## Responses to the referee and community comments on gmd-2023-100.

### Reply to Anonymous Referee #1

**Figure 1: Time evolution of TSI, integrated SSI in 200-400 nm and 400-700 nm bands, as well as mid-energy electron (MEE) ionization rate at 0.001 hPa from the CMIP6 forcing data set (dashed) and the CCMI-2022 forcing dataset (solid). The overlap region of both datasets is 2015-2020.**

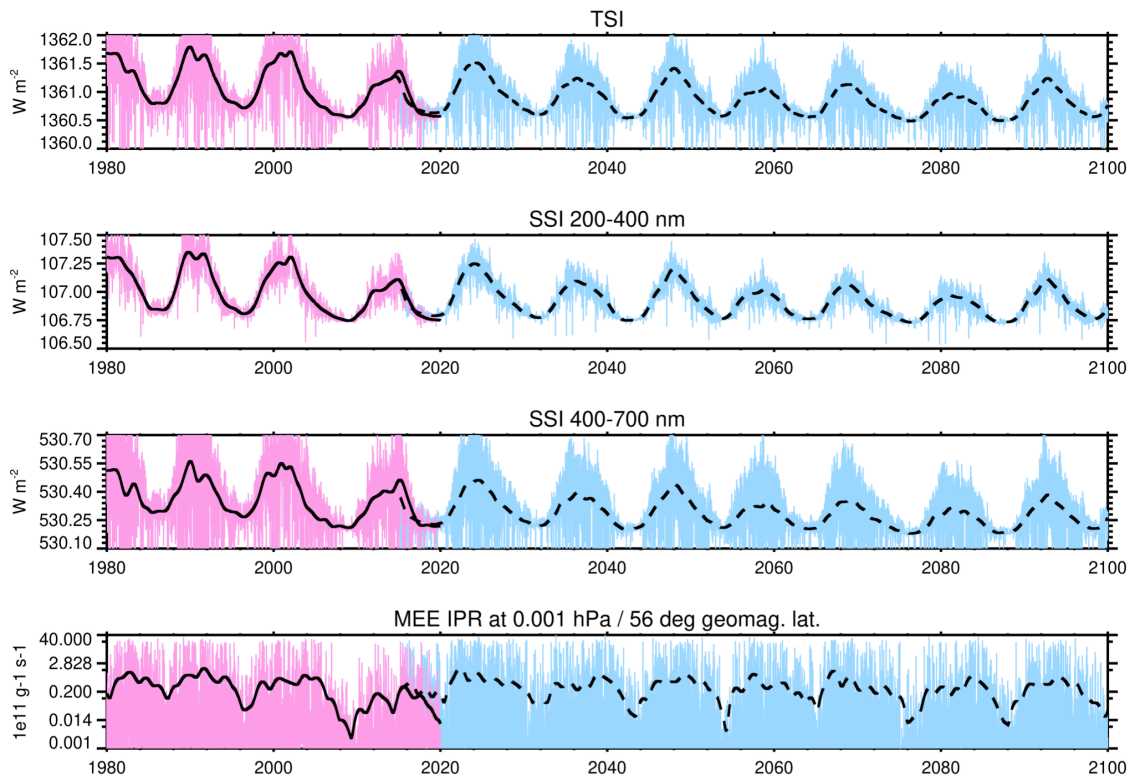
L239-L241 There are non insignificant differences between what solar irradiance models and observations give for recent TSI [9], with much larger uncertainties over longer timescales [5]. The reduction in TSI over the 21st century in the projection [6] should probably be mentioned. Is it too early to assess it? My opinion is that it was too speculative to propose for use with climate models.

Reply: This reduction in CMIP6 is a plausible scenario, thus of course speculative. However, we have produced an extended historical CMIP6 dataset up to 2020 for the SPARC's CCM1-2022

model intercomparison exercise (see <https://solarisheppa.geomar.de/solarisheppa/ccmi2022>), which shows that the CMIP6 projection for the 2015-2020 period was even sub-estimating the reduction of the solar activity level, in particular during the solar cycle minimum around 2019. See Figure 1 below.
